**MEETING NOTICE AND AGENDA**  
**TECHNICAL ADVISORY COMMITTEE**  
**OF THE**  
**SEASIDE BASIN WATER MASTER**

**[Note Revised Meeting Date] DATE: Wednesday, April 15, 2015**

# Peer Review of Seaside Basin Groundwater Modeling

Re: Response to Draft Peer Review of Seaside Basin Groundwater Modeling Studies

## The Missing Pumping Trough

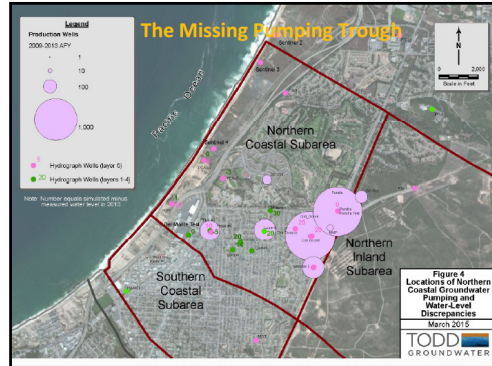
(a) There was some discrepancy between simulated and actual data in some locations. The biggest discrepancies were in the eastern part of the Northern Coastal Subarea. A pumping trough there was not identified by the modeling.

## Head-Dependent Boundaries

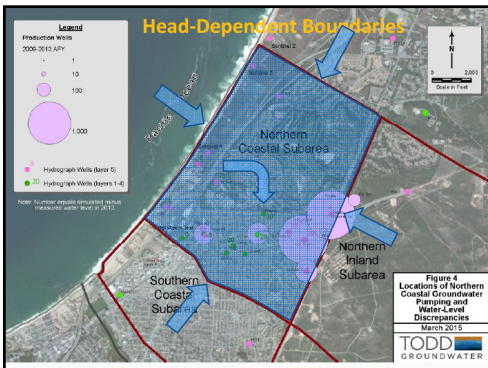
- (b) He hypothesized that there might be some problem with one or more of the five head-dependent boundaries shown in Figure 4, so he had HydroMetrics do some sensitivity modeling of these.
